RESPONSE TO REQUEST FOR ADDITIONAL INFORMATION

APR1400 Design Certification

Docket No. 52-046

RAI No.: 255-8285
SRP Section: 03.08.05 – Foundations
Application Section: 03.08.05
Date of RAI Issue: 10/19/2015

Figure 2. Location of example node 1000002

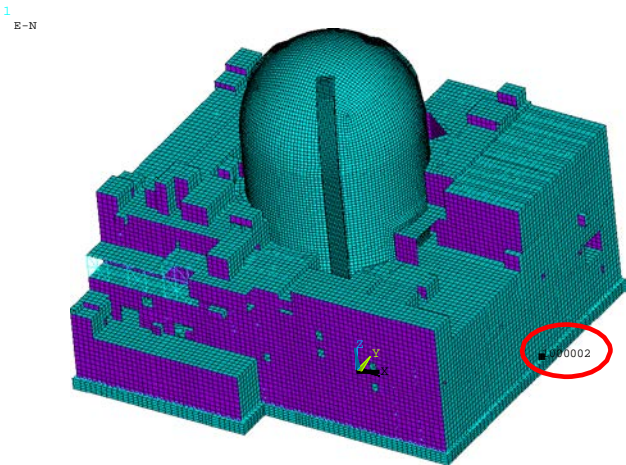
In the new NI basemat analysis, in order to determine the maximum seismic responses from structural responses from three spatial earthquake components, the 100-40-40 rule described in Regulatory Guide (RG) 1.92 is applied in APR1400 project. To justify the adequacy of the 100-40-40 rule, the square root of the sum (SRSS) is compared. For example, using all nodes in the basemat, node number 1000002 in auxiliary building is arbitrarily chosen for comparison between the 100-40-40 method and SRSS method as shown Table 4 and 5. Only the reaction force (FZ), and one moment (MY) are considered at a section in this example for simplicity. Figure 2 shows the location of node number 1000002.

Figure 3 Seismic Input Response Spectra in the RCB Shell & Dome FE Model (5%)

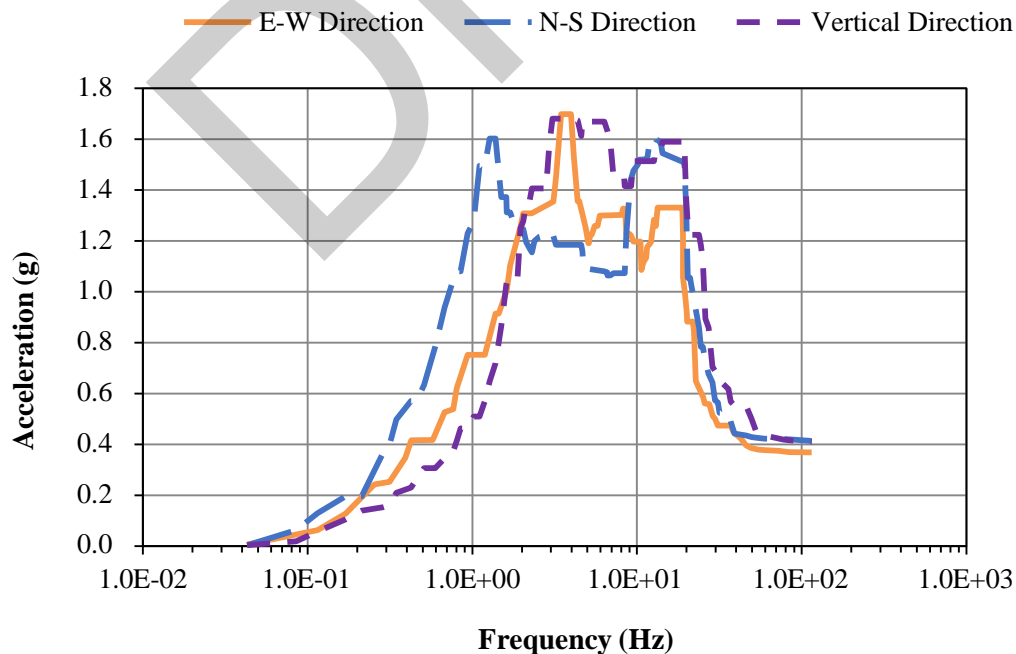
- (c) For the response spectrum analysis, each floor response spectra is used in the RCB internal structure and shell & dome analysis to consider the effects of seismic excitation in the X, Y, and Z directions.

For the RCB shell & dome analysis, the three (two horizontal and one vertical) response spectrum at EL. 78'-0" are used as the base excitation. Figure 3 shows the response spectrum of the SSE at EL. 78'-0" with 5% damping.
